## URGENT MEDICAL DEVICE RECALL

### HeartMate 3™ Left Ventricular Assist System Catalog #106524US LVAS KIT, HM3

May 21, 2018

## Appendix 1: Updated IFU Information

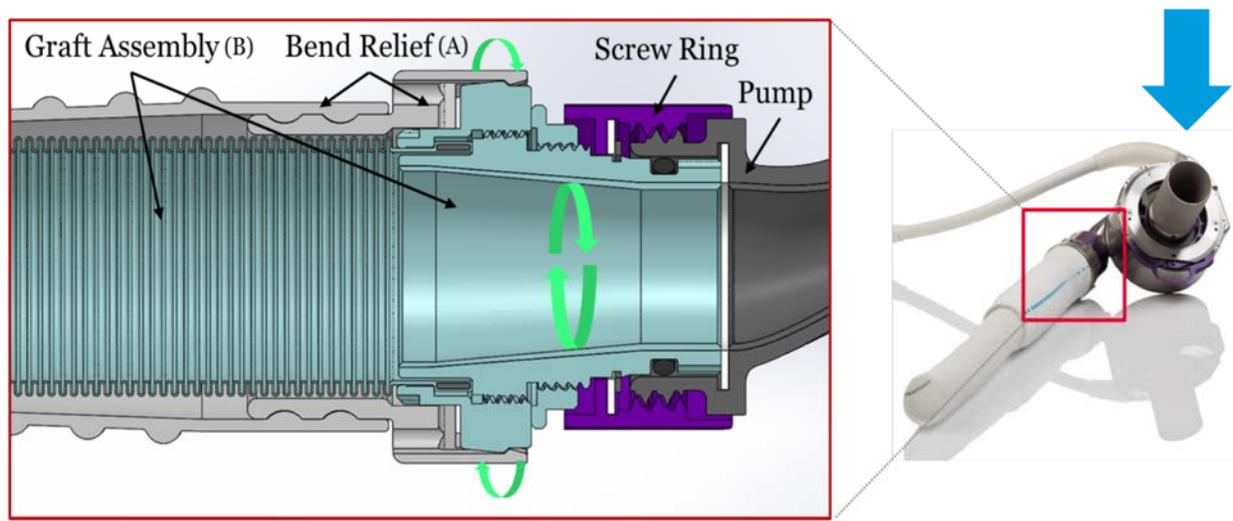
The HM3 is designed to allow for Outflow Graft connector rotation by the surgeon after connection to the pump, so that proper alignment of the Outflow Graft can be made during implantation without disconnecting the Outflow Graft connector from the pump. Appropriate tightening of the Screw Ring (see below) during implantation reduces, but does not eliminate, the propensity of the Outflow Graft connector to rotate. *In vivo*, normal forces can rotate the metallic Outflow Graft connector; if the rotation is in one direction only (instead of back-and-forth (clockwise/counter-clockwise)), then twist will accumulate in the graft. Accumulation of Outflow Graft twist can occur at any time point post-implantation. The twist may deform the Outflow Graft (a twist occlusion) and reduce or stop pump flow. The time course from the beginning of an accumulation of twist to an occlusion is unknown and may be variable among patients. Occlusion of the HM3 Outflow Graft often requires urgent surgical intervention.

During implant, when attaching the Outflow Graft to the Pump Cover, a clicking sound will be heard as the Screw Ring is tightened. Continue turning the Screw Ring clockwise until it comes to a complete stop and stops clicking. Firmly hand-tightening the Screw Ring may reduce the risk of Outflow Graft twisting by increasing the resistance to metallic Outflow Graft connector rotation. To avoid damaging the Outflow Graft assembly, do not use tools to tighten the screw ring. This updated information (see Appendix 1) has been incorporated into the Instructions for Use.

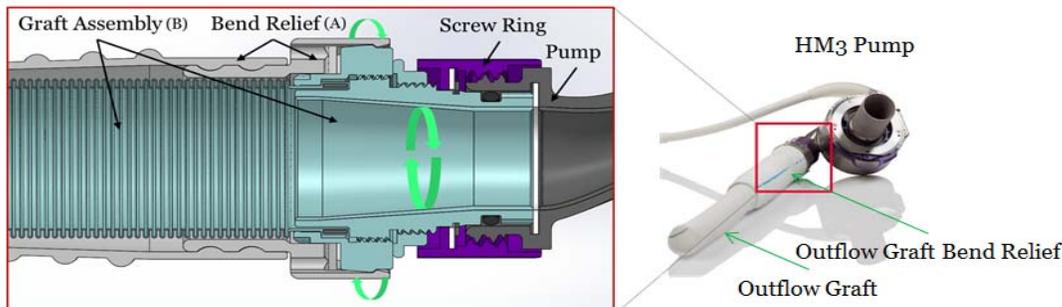
Normal *in vivo* forces associated with heart beats, respiration and patient activity can cause small rotations between the Outflow Graft Bend Relief (A) and the pump. These rotations are expected and appear to be 'back and forth' without accumulation in either direction. However, there is the potential for these forces to be preferentially translated to the outflow graft (B) in either the 'back' or 'forth' direction which may deform the outflow graft and reduce pump flow. The accumulation of outflow graft twist can occur at any point beyond implant. Postoperative twisting and occlusion of the HM3 outflow graft may result in the need for surgical intervention following the original implant procedure.

- During implant, when attaching the Outflow Graft to the Pump Cover, a clicking sound will be heard as the Screw Ring is tightened. Continue turning the Screw Ring clockwise until it comes to a complete stop and stops clicking for a firm hand tightened connection.
- If a low flow alarm persists at any time following implant, and other potential causes such as hypertension, low preload, right-heart failure and inflow occlusion have been considered for cause, a Computed Tomography (CT) angiography should be taken to identify the possibility of an outflow graft twist occlusion.
- In the event surgical repair of the outflow graft is needed due to a twist occlusion, the Outflow Graft Bend Relief should be reattached in its original state or repaired to prevent further kinking or occlusion of the graft.
